Job: TCPJ10-101 Portland Jetport Expansion

Submittal Title: FIRE ALARM SHOP DRAWINGS / CALCULATIONS

Here is our reply to the comments relating to the revised FA drawings that John Hale reviewed with you last week.

FIRE ALARM SYSTEM NETWORK RISER DIAGRAM PORTLAND INTERNATIONAL JETPORT 1001 WESTBROOK STREET PORTLAND, MAINE 04102	
DRAWN BY: L.SANTORA	DATE: 06/28/10
CHECKED BY: A.PRENTISS	DATE: 07/23/10
PROJECT NUMBER: 147-951655801	
SHEET TITLE: FIRE ALARM SYSTEM NETWORK RISER DIAGRAM	
SHEET NUMBER: FA-201

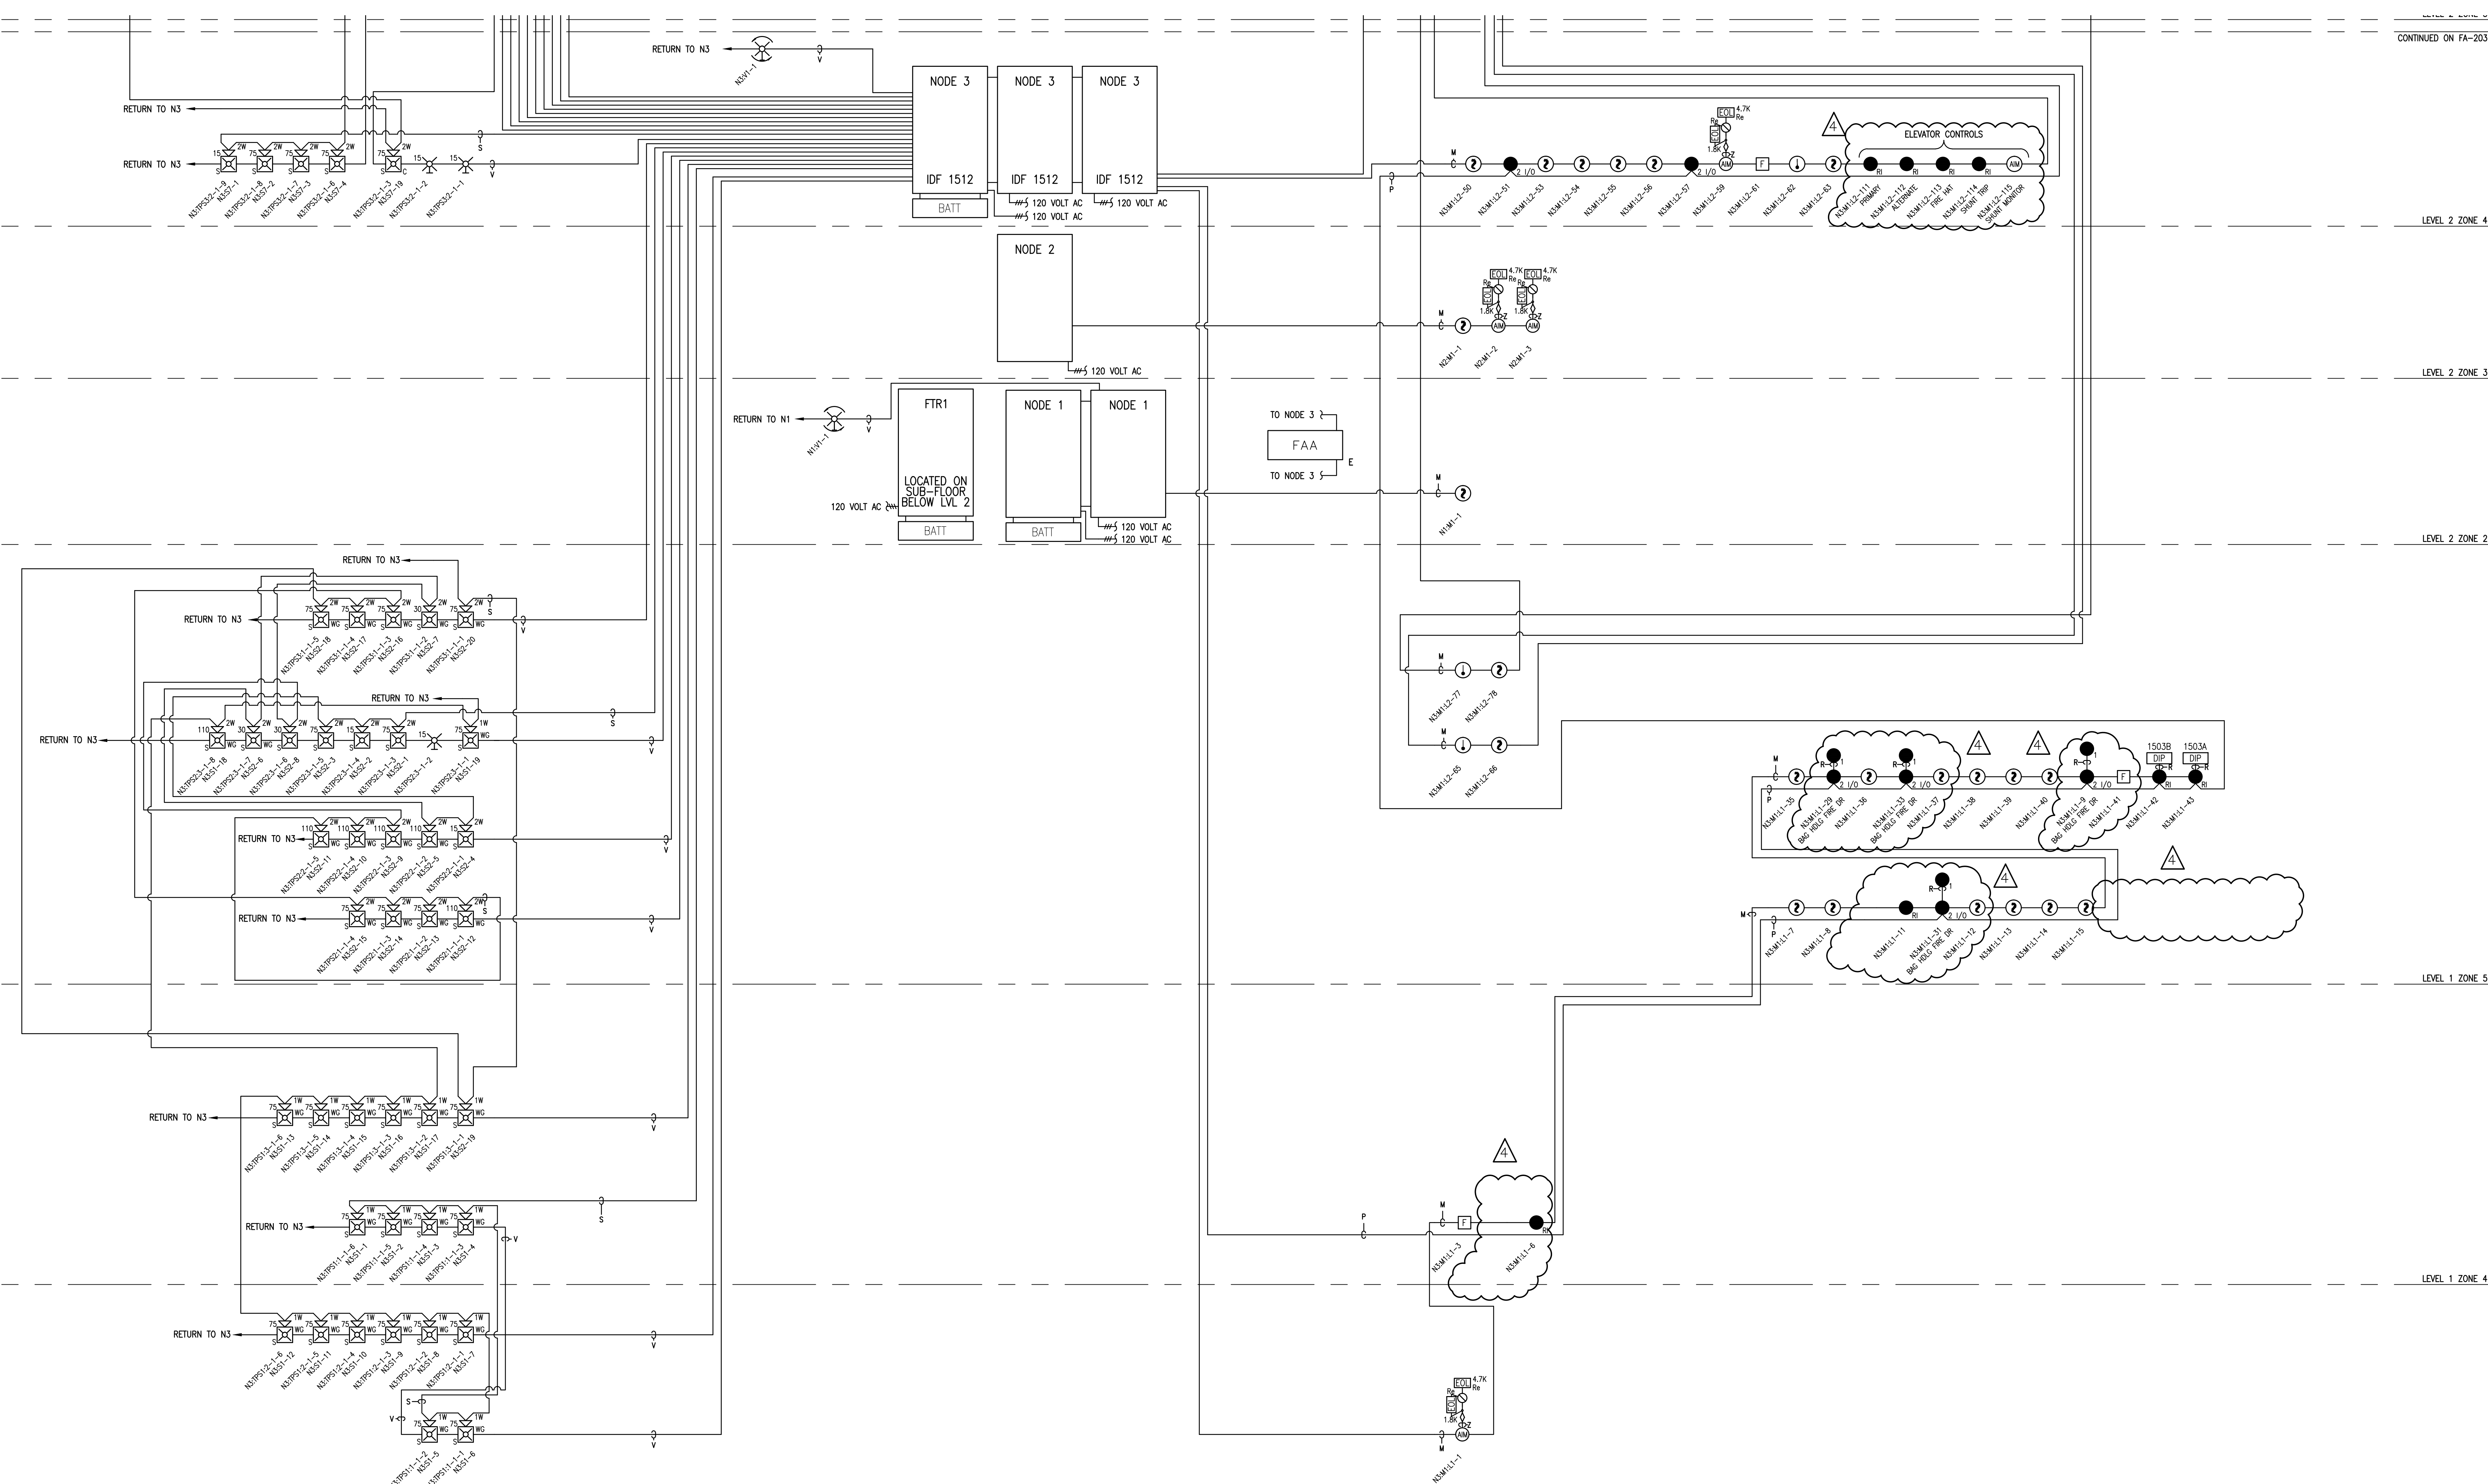
FA-201 through 204:

-Changes/corrections/modifications have been made.
